ADDENDUM NO. 1

DATE: SEPTEMBER 21, 2023
TO: ALL PLAN HOLDERS
ENGINEER: MIKE DOMBROWSKI, MRD ASSOCIATES, INC
CONTACT: 850-654-1555
PROJECT: 8TH, 9TH, AND 10TH STREET WEST DUNE WALKOVER
BID DUE DATE: MONDAY, OCTOBER 2ND, 2023.

Figure 1. Existing Trashcan Holder

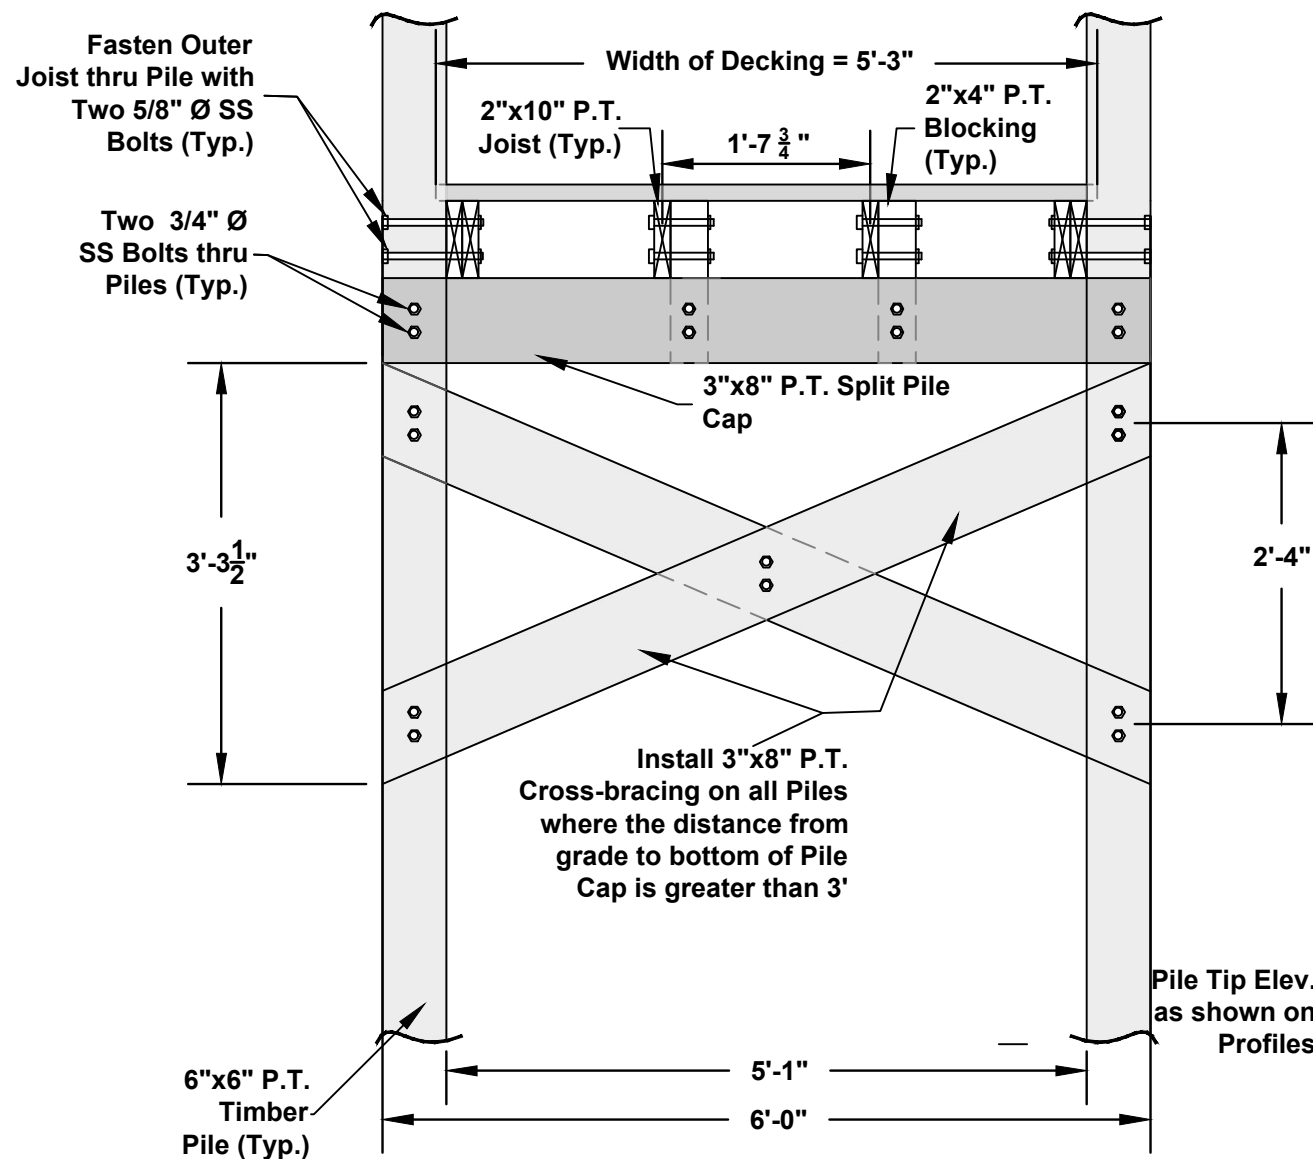
Question: Please provide a clarification on "Move trashcan and sign behind post and rope" as indicated on Sheet 3 "Site Plan" of the drawings.

Answer: The existing trashcan frame, shown below in Figure 1. shall be demolished and a new trashcan holder shall be constructed behind the Post and Rope fencing. The existing sign, shown below in Figure 2. shall remain intact and be moved behind the Post and Rope fencing.

TYPICAL DETAILS
8th Street West Dune Walkover
Franklin County Board of Commissioners
33 Market Street, Suite 305, Apalachicola, Florida, 32320

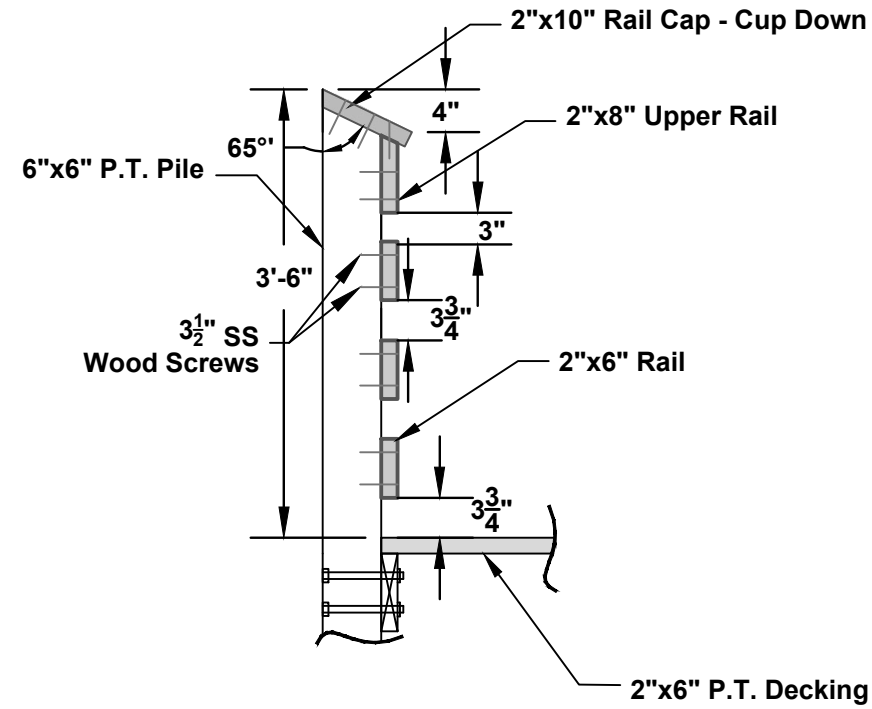
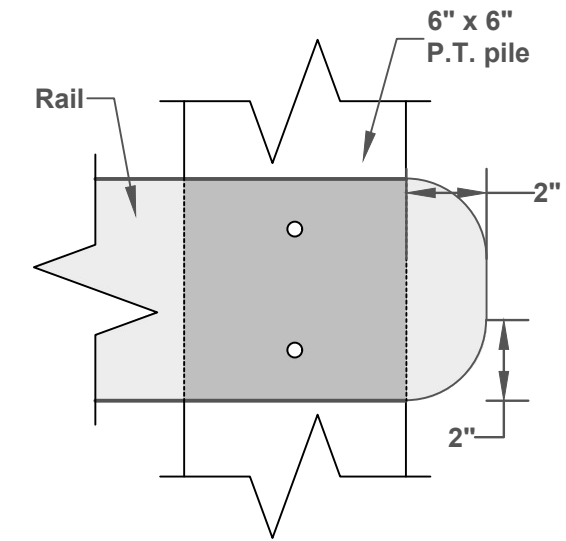
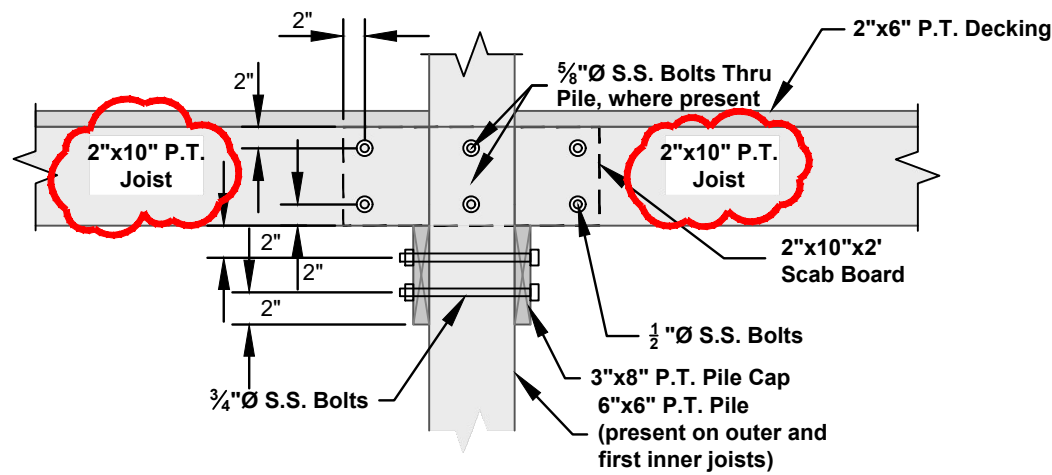
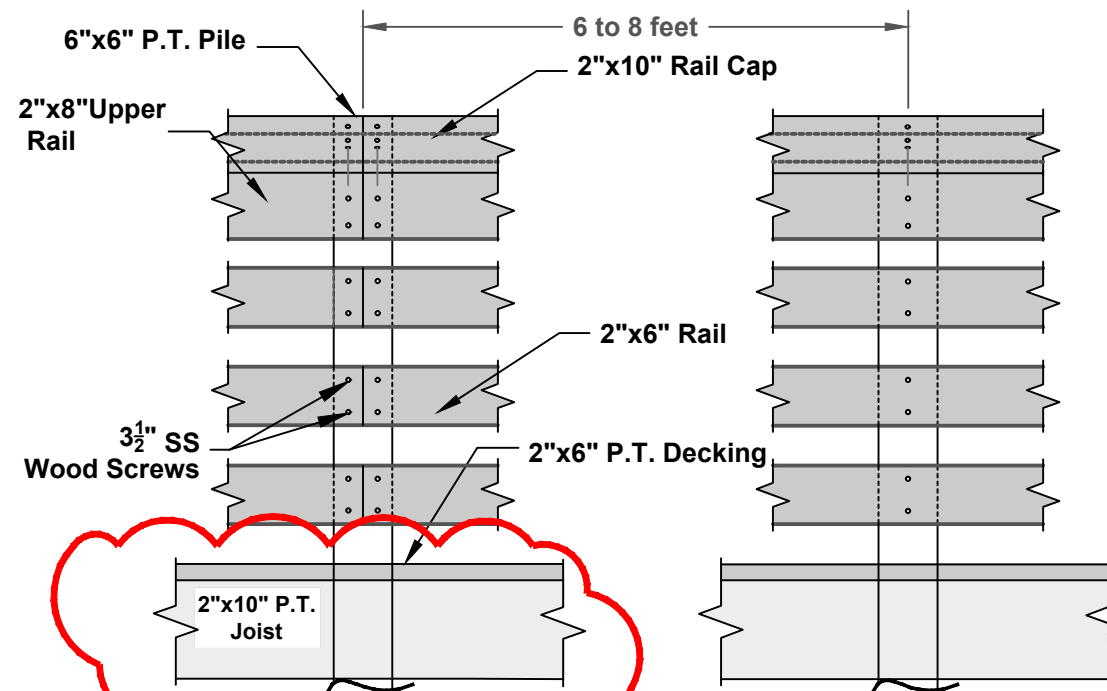
Question: On the engineered drawings that were sent out it shows 2 different sizes for the stringers. It shows using a 2x10 on one drawing and a 2x8 on another. I am just trying to figure out which you would like to use as there is a price difference between a 2x10 and using 2x8 Yellow#2.

Answer: All stringers shall be 2x10. See attached revised details. These details shall apply to all three dune walkovers.
